SUBJECT: ISSUANCE OF AMENDMENT NO. 29 TO FACILITY OPERATING LICENSE  
NO. NPF-41, AMENDMENT NO. 16 TO FACILITY OPERATING LICENSE  
NO. NPF-51, AND AMENDMENT NO. 4 TO FACILITY OPERATING LICENSE  
NO. NPF-74, FOR THE PALO VERDE NUCLEAR GENERATING STATION, UNITS  
1, 2 AND 3, RESPECTIVELY, (TAC NOS. 66798, 66799 AND 66800)

The Amendments revise Section 6 of the Technical Specifications for each of the three Palo Verde Units to incorporate changes reflecting a revised organizational structure for the Palo Verde plant.

SAFETY EVALUATION BY THE OFFICE OF NUCLEAR REACTOR REGULATION  
RELATED TO AMENDMENT NO. 29 TO FACILITY OPERATING LICENSE NO. NPF-41,  
AMENDMENT NO. 16 TO FACILITY OPERATING LICENSE NO. NPF-51  
AND AMENDMENT NO. 4 TO FACILITY OPERATING LICENSE NO. NPF-74  
ARIZONA PUBLIC SERVICE COMPANY, ET AL.  
PALO VERDE NUCLEAR GENERATING STATION, UNIT NOS. 1, 2 AND 3  
DOCKET NOS. STN 50-528, STN 50-529 AND STN 50-530

ONSITE ORGANIZATION  
Figure 6.2-2

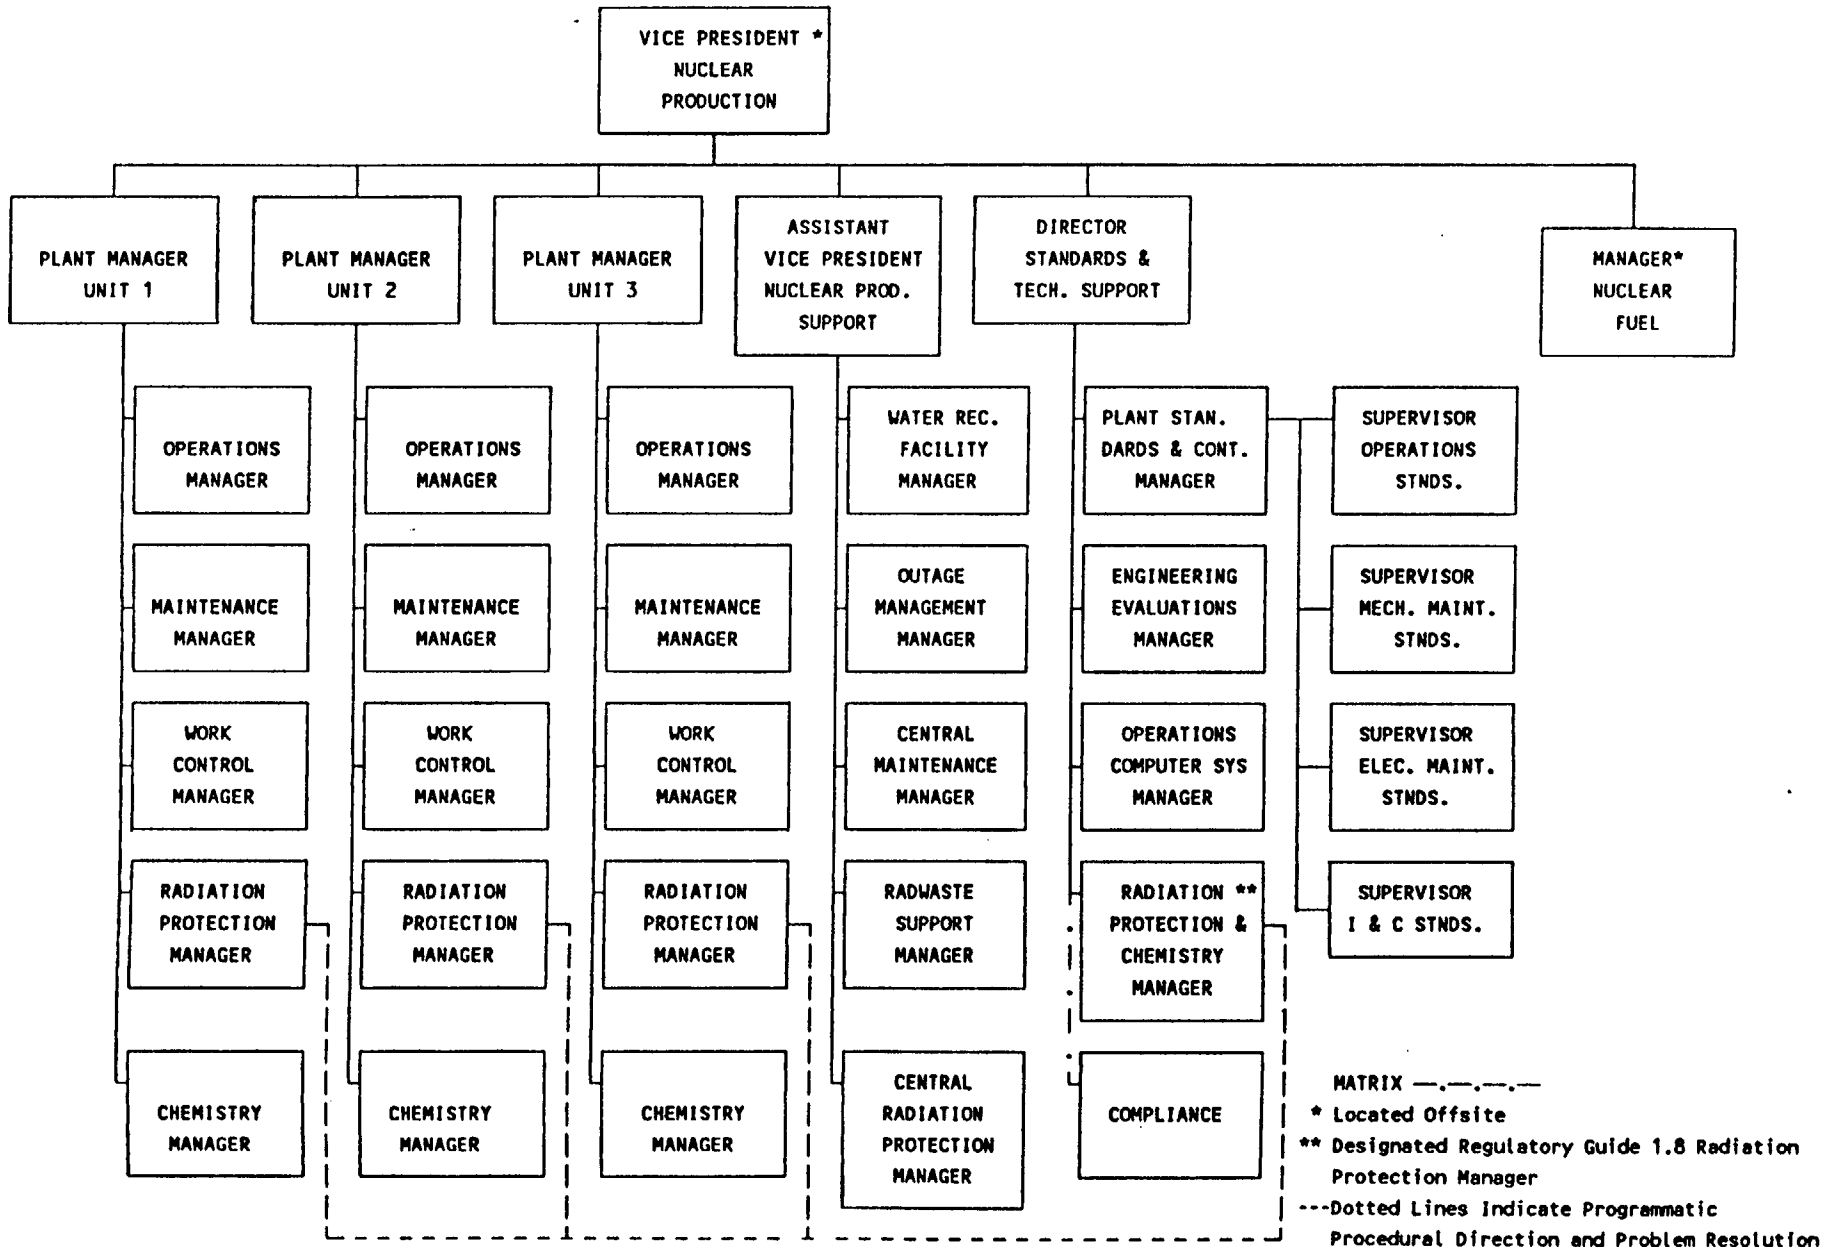
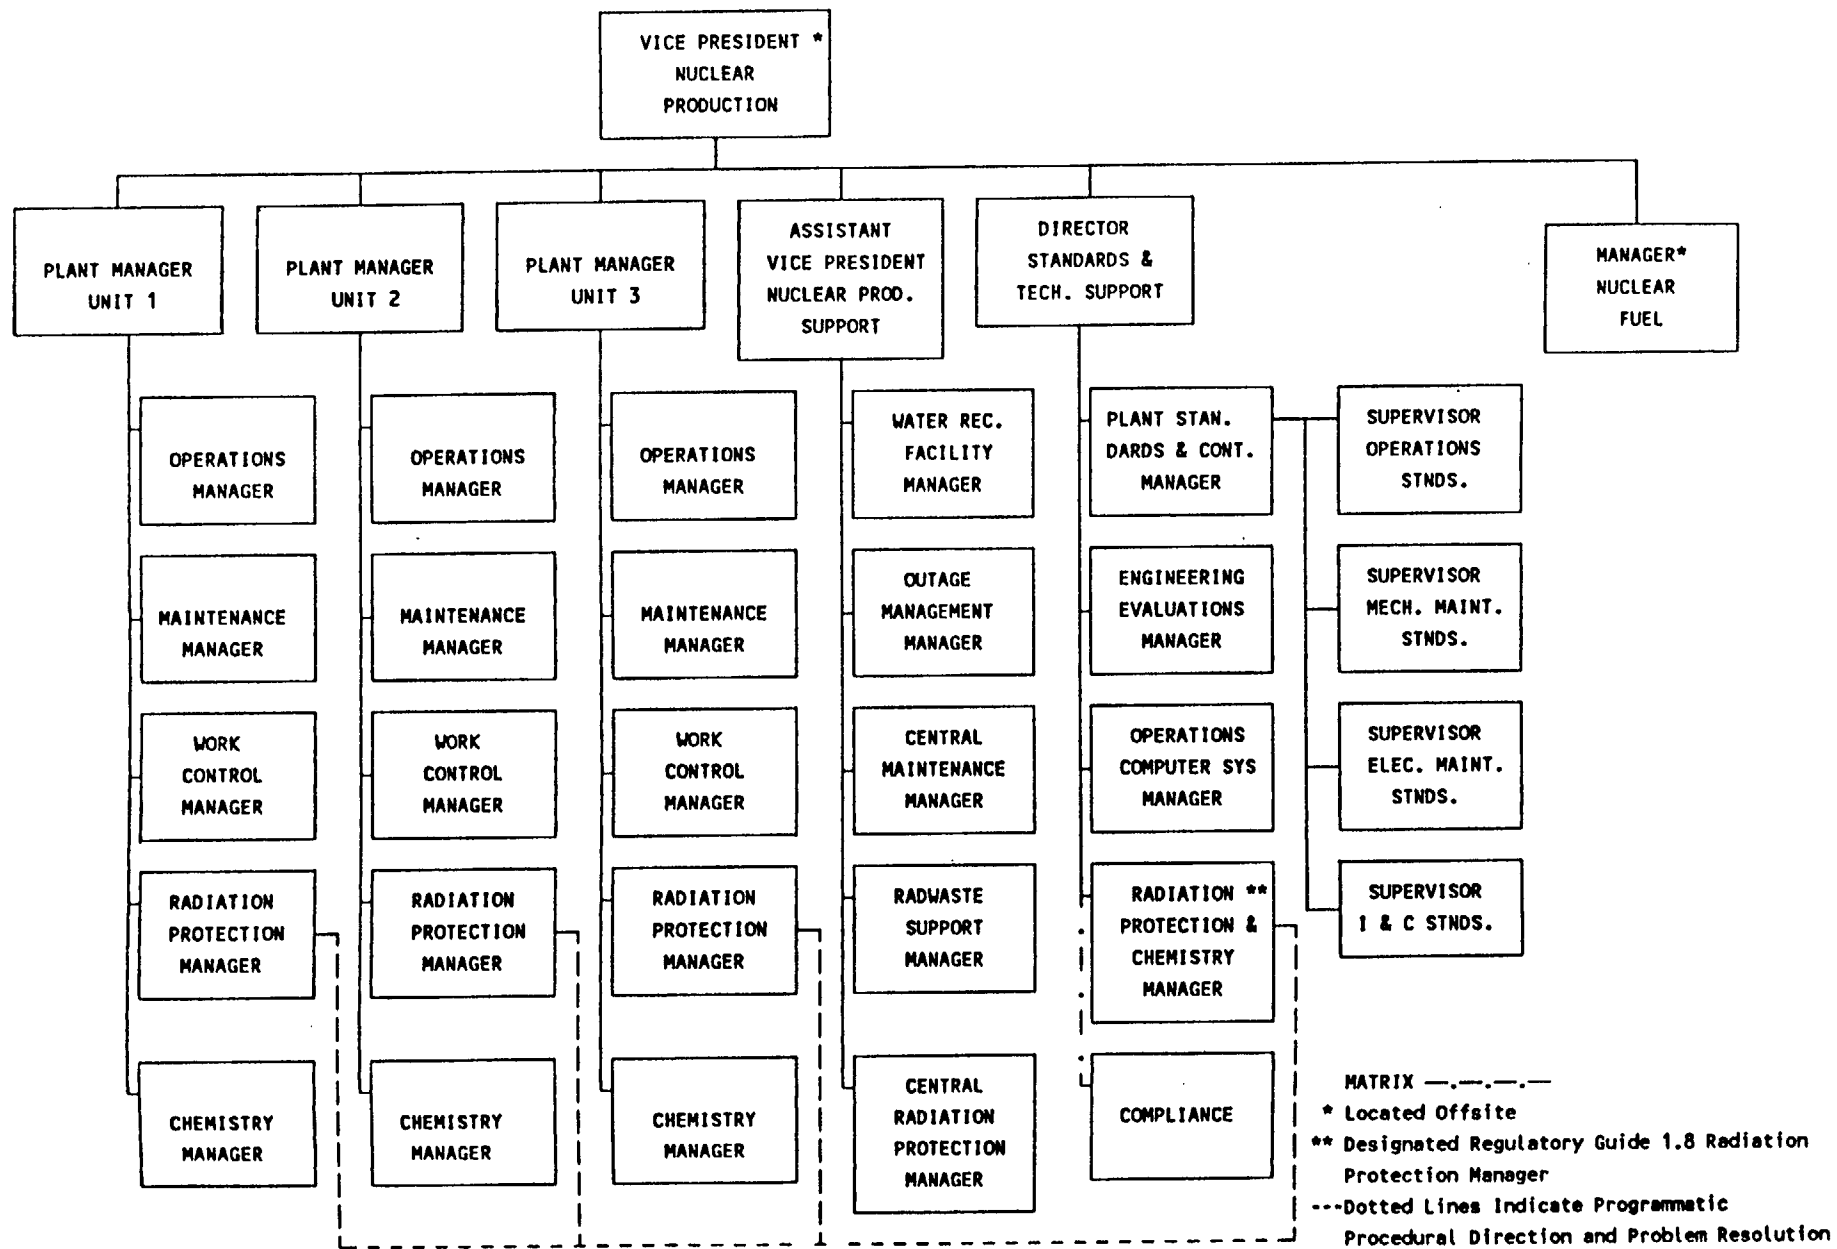
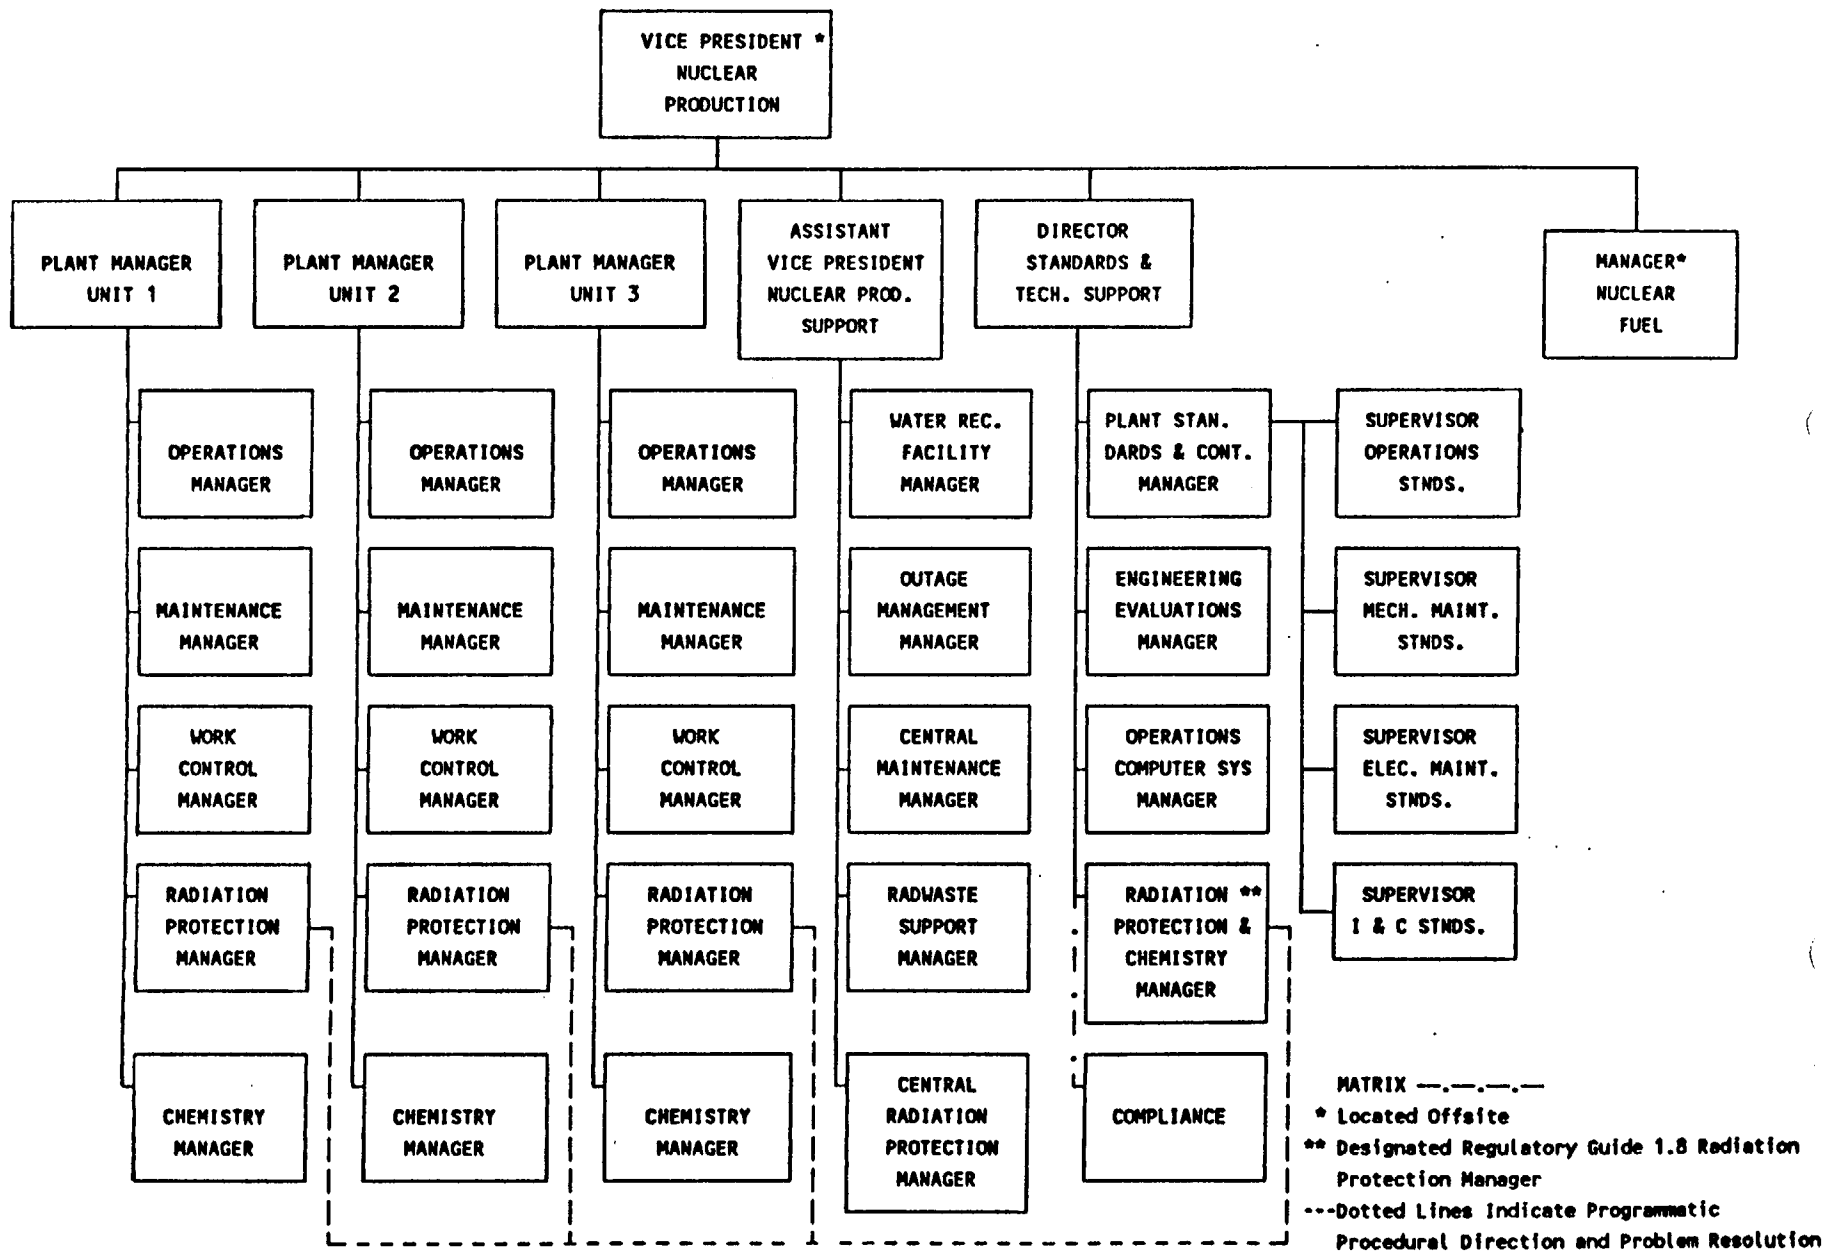
The proposed change requests an amendment to the Palo Verde Units 1, 2 and 3 Technical Specifications, Section 6, Figures 6.2-1 and 6.2-2, "Offsite Organization" and "Onsite Unit Organization." The change is administrative in nature in that the Manager of Nuclear Fuels will now report to the Vice President of Nuclear Production in lieu of reporting to the Director of Engineering and Construction. The change is intended to facilitate communications between the management of the Arizona Nuclear Power Project and the nuclear fuel supply vendor.
